JEROME FREIBAUM LOT 4

ADMINISTRATIVE SUBDIVISION NO.620210080

Proposal to create two (2) lots for one (1) single-family detached dwelling on each lot, on 0.59 acres of R-60 property on Elgin Lane in Bethesda.

Figure 4 – Tree-Save Plan – Removals and Retention

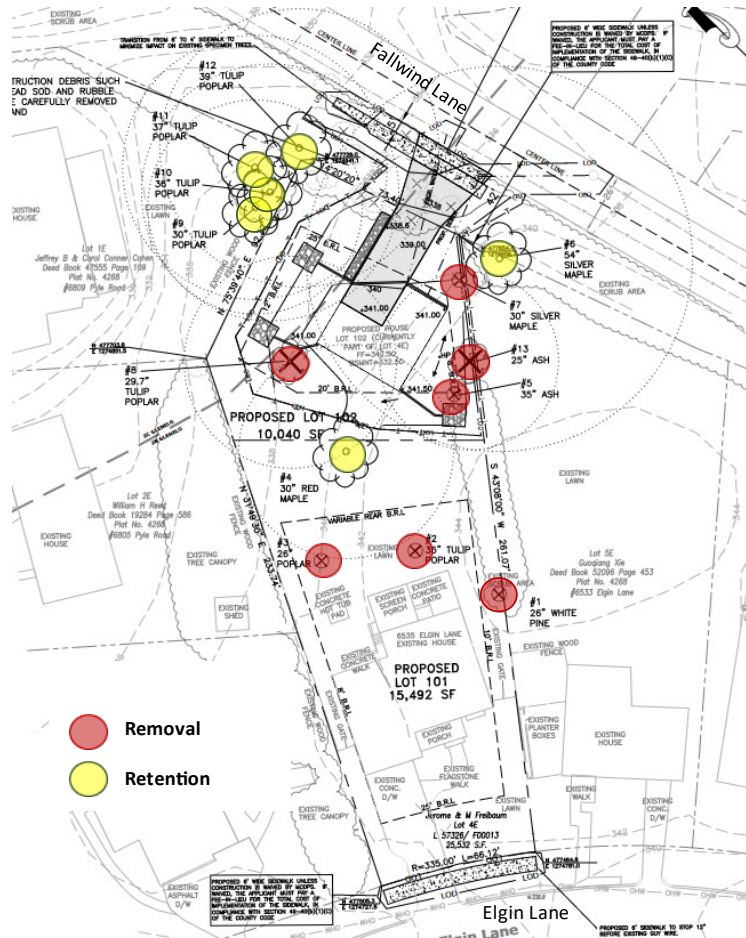
Concerns were expressed that the Proposal will result in the loss of tree canopy from the Site.

The Tree Save Plan shows a total of thirteen large canopy trees (those measuring 24-inches in diameter or greater) impacted by the Proposal. Five were previously removed with the reconstruction of the dwelling on Lot 101 and two are proposed for removal with the development of Lot 102. The remaining six are to be retained, protected during construction and their condition monitored for three years after work is completed. These trees are illustrated in Figure 4 below.

In accounting for these impacts, the Tree Save Plan includes planting of six, five-inch caliper canopy trees. This is one greater than is required to conform with mitigation requirements for the Proposal’s tree removals. In addition to meeting this requirement, four ornamental trees and 27 evergreen trees will be provided. Planting locations are concentrated on the periphery of Lot 102, with one new tree proposed next to Elgin Lane on Lot 101. Most proposed plantings are purposefully sited outside the building restriction line, where future development is not permitted. The planting layout is also serves as visual screening between Lot 102 and abutting properties. This is shown in Figure 5.
